RESIDENTIAL DEVELOPMENT COMPROMISING ERECTION OF UP TO 204 HOUSES WITH PARKING TOGETHER WITH CONSTRUCTION OF VEHICULAR/PEDESTRIAN ACCESSES OFF STONEY LANE, PEDESTRIAN ACCESS OFF CUMBER LANE, SUB-STATIONS, FOUL WATER PUMP STATION, SUDS BALANCNG POND AND ASSOCIATED PUBLIC OPEN SPACE, LANDSCAPING AND ASSOCIATED WORKS.

PLANNING REFERENCE 25/00672/FUL

In response to the comments received from Laura Howcroft on behalf of Merseyside Police, dated 30th March 2026, in relation to the application above, please find our responses below with any relevant information or updated documents attached.

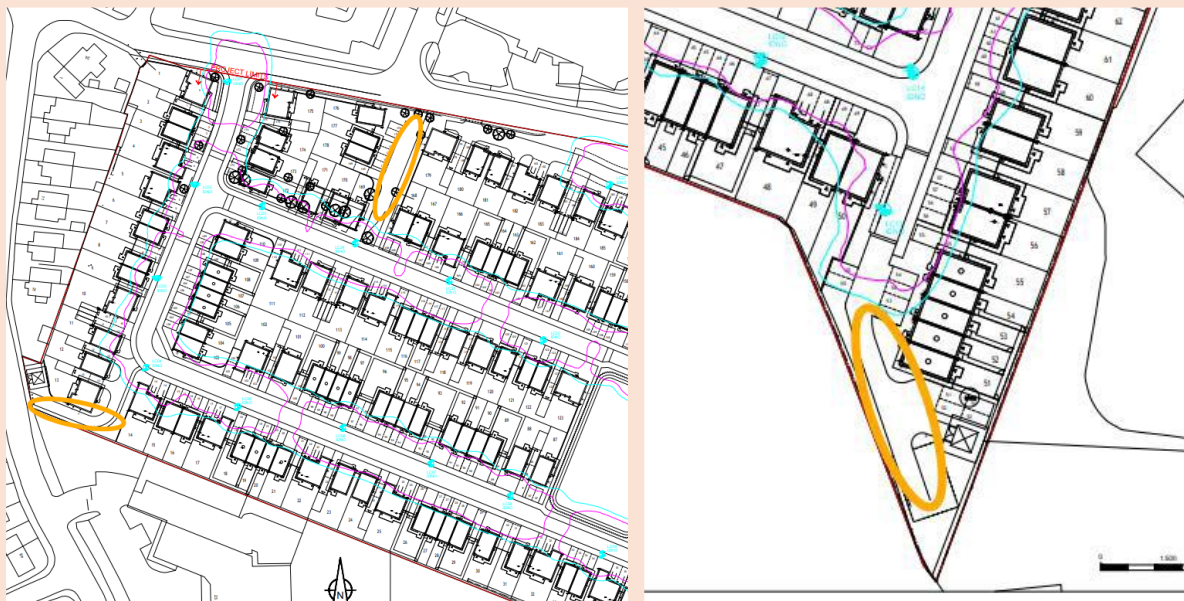
The lighting design does not appear to include any lighting provision at the locations circled orange on the below extracts from the S38 Street Lighting Design drawings. This includes the area that we have significant concerns over, at the south eastern most extent of the site. We request that lighting is provided along these streets.

As set out above in response to your comments, and in conjunction with comments received from Highways, we have included Lighting Columns to the areas you have circled orange above.

Please note that we have shown a Lighting Column to the Cumber Lane access, however we would like to request that you consider Bollard Lighting to this area due to the proximity of the plots and their interface with the overspill from the Lighting Column.
